November 27, 2017

Sherborn Village
59 North Main Street
Sherborn, Massachusetts
EDC Job No.: 3438

The following are responses in red to a letter of peer review dated, September 12, 2017, by Professional Services Corporation, PC.

GRADING & UTILITIES
#59 NORTH MAIN STREET
SHERBORN, MASSACHUSETTS

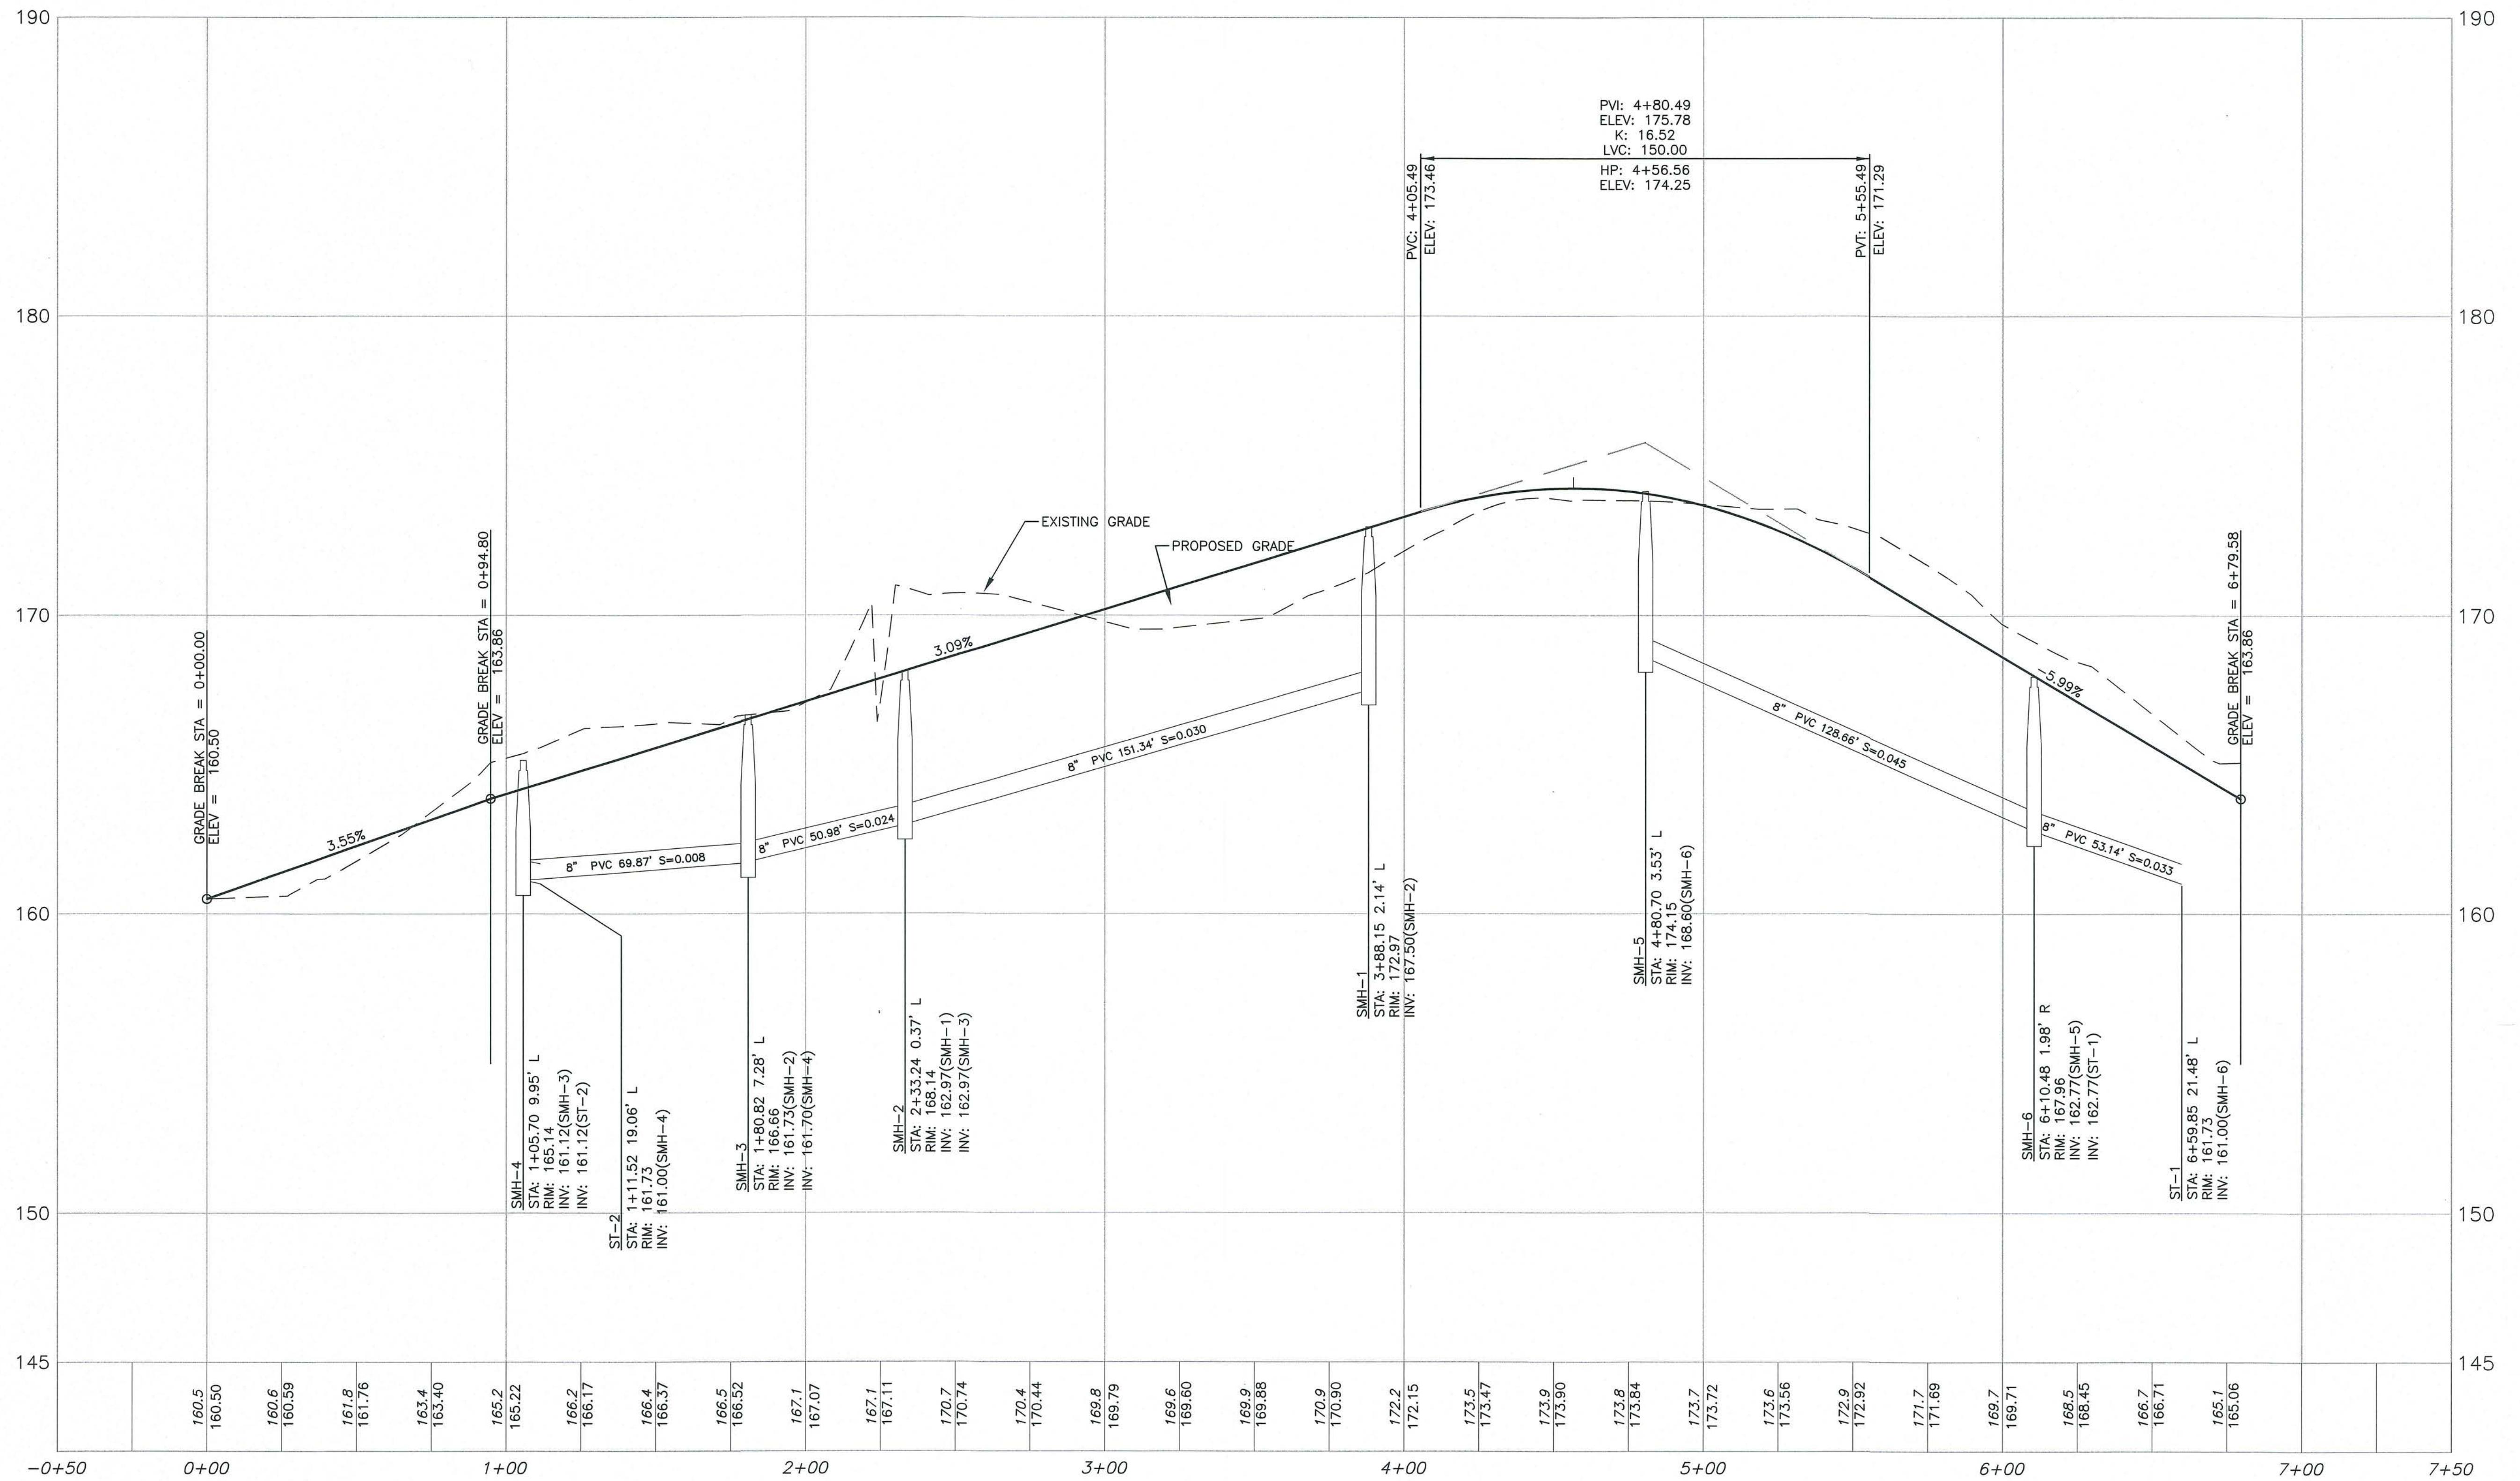
23. The Infiltration Trench System detail on Plan Sheet 6 provided the design bottom elevation for each of the six (6) Cultec Systems. Estimated Seasonal High Groundwater (ESHGW) beneath each system should be provided in this table. A minimum 2-foot vertical separation to ESHGW is required beneath the stone for each system. If less than four feet is provided, then groundwater mounding calculations will also be required. *High ground water elevations have been added to the table.*

65. The plan shows all the on-site galleys that accommodate runoff are retention systems. In order for each system to be effective, it must be empty prior to a storm event. All basins must be designed such that spring high groundwater is two feet below the bottom of the basin. Soils information should be provided. **All Cultec chambers have been designed to be at least 2-feet above high ground water.**

FILE NO.: 3438	LIGHTING & LANDSCAPE
DATE: JULY 25, 2017	
PLAN NO.: 6	7

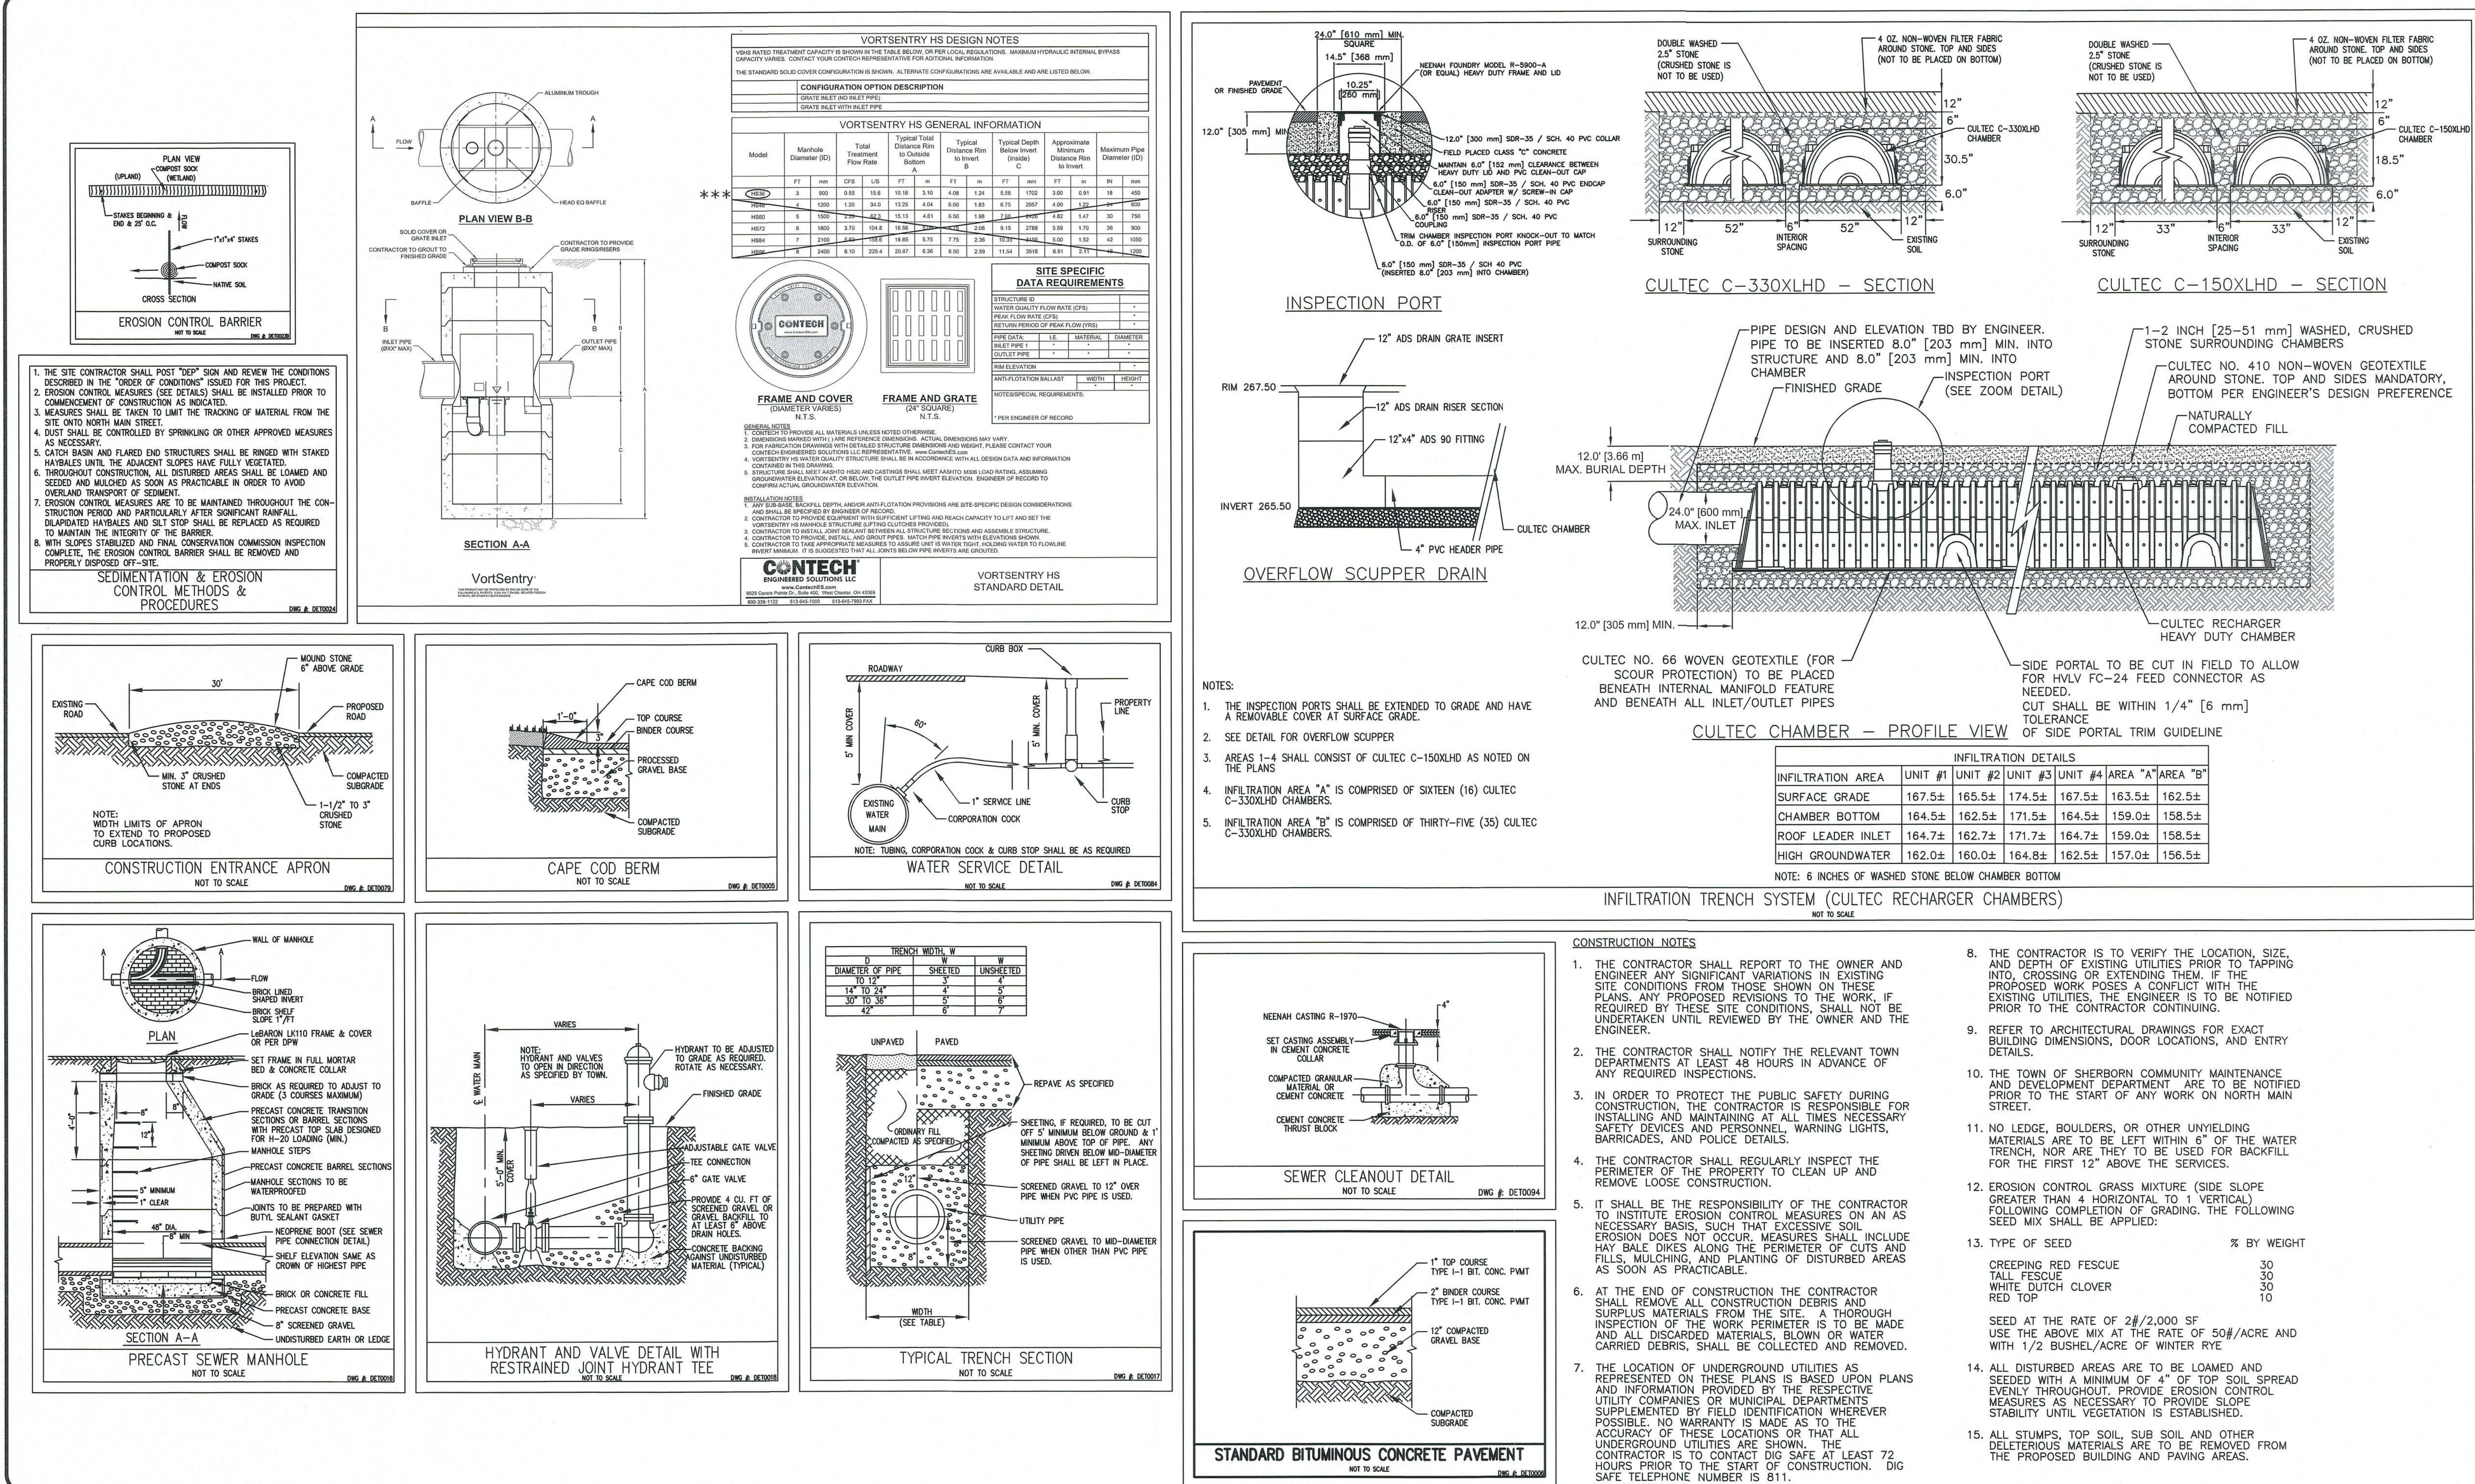
24. Project lighting is not indicated within the site. Proposed lighting should be developed with photometrics using specific light fixtures that are consistent with residential scale and style typically acceptable in the town. *Lighting details and photometrics have been added to Plans.*

25. Please indicate whether a streetlight is proposed for the project entrance at its intersection with North Main Street. *A pole mounted light is set to be 40°± from the intersection with North Main Street as shown on the lighting plan.*
